SERVICE PROCEDURE

REFERENCE: FSA 202601

SUBJECT: Air Filter Clogging Warning V2

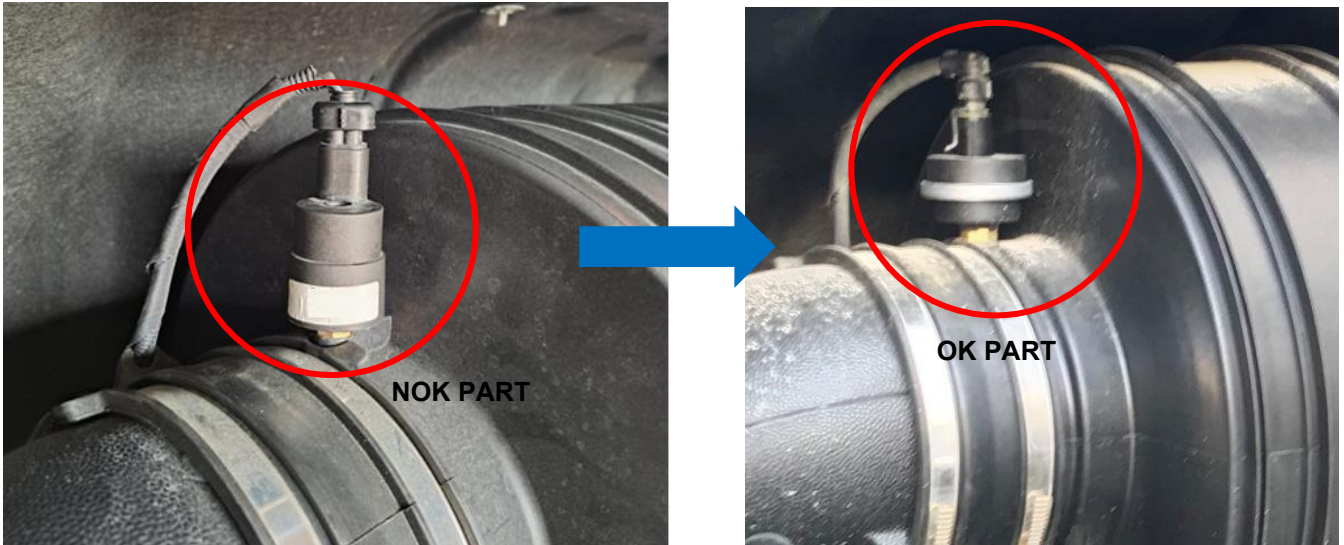
In F-MAX and F-LINE vehicles due to unnecessary warning message on cluster, air clogging sensors must be replaced.

The air clogging sensors with part numbers "RC46-9N622-AB" must be replaced with "DC46 9N622 AA" and tightened clockwise by hand after threading.
